## 2016 example of gaps in flow data: Steamboat Slough

Questions after review of DWR “critical year average” graphic:

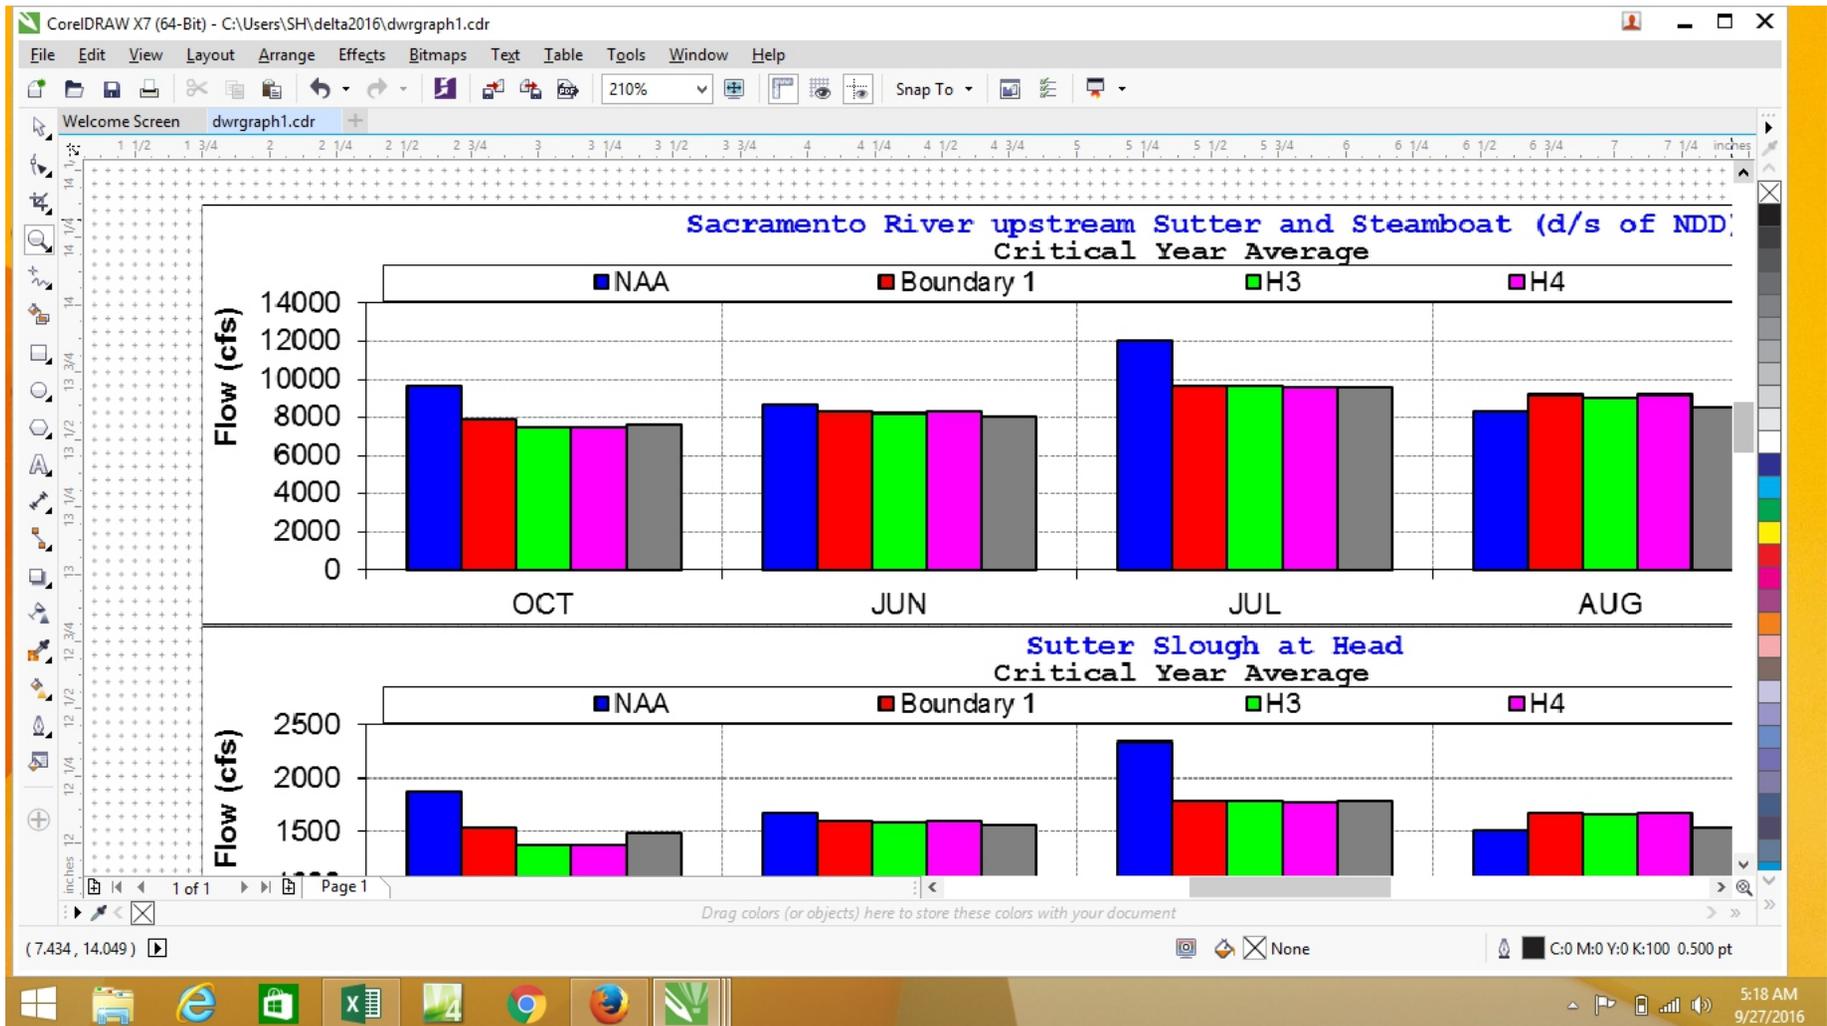
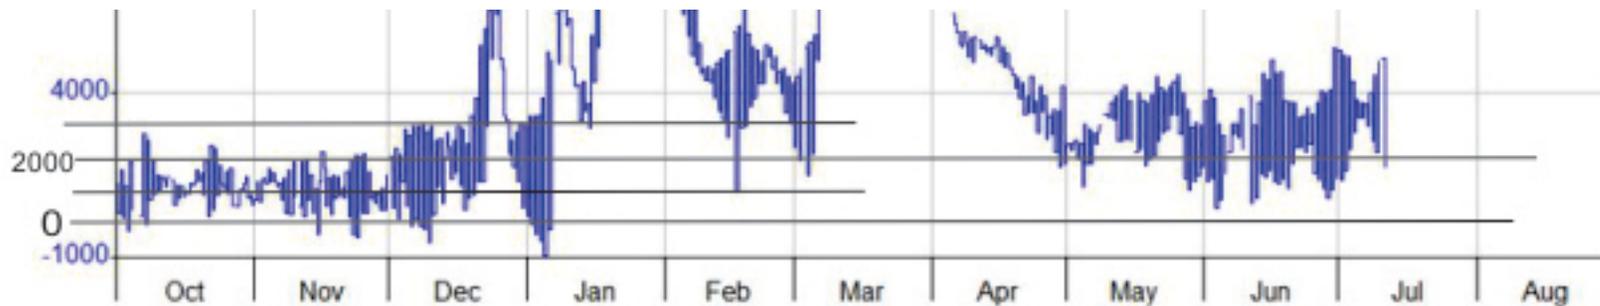
1. Note the Disclaimer on DWR graphic: “The information provided represents the monthly average flows at the locations you requested. The actual flows reflecting the effects of natural tide could be significantly different from those shown in the figures”. Please describe possible range of differences. Higher flows? Lower flows?

2. Which computer model was this based upon? Which time period? Is this similar to flows for 2015?
3. How much in-Delta use is accounted for in the flow data? If not included, why not?

4. It appears that currently, from your graphic, in September there is a monthly average flow of between 700 to 800 cfs on Steamboat Slough above the confluence with Sutter Slough. I asked for flows on lower Steamboat Slough by Snug Harbor. Have you modeled lower Steamboat Slough flow and if so, why wasn't it provided? If it wasn't modeled, how can you be sure SHR surface water rights and use of shallow aquifer for fresh drinking water won't be affected by proposed low flows? Have you reviewed the impacts to area drinking water wells from the last 5 years of excessively low flows in the North Delta?

5. Is 700 cfs average flow sufficient to maintain fresh surface and/or aquifer drinking water along Steamboat Slough, in your opinion as an expert in flow modeling? On Steamboat Slough at the lower gage location? Do you know of a better model that could provide this kind of detailed data?
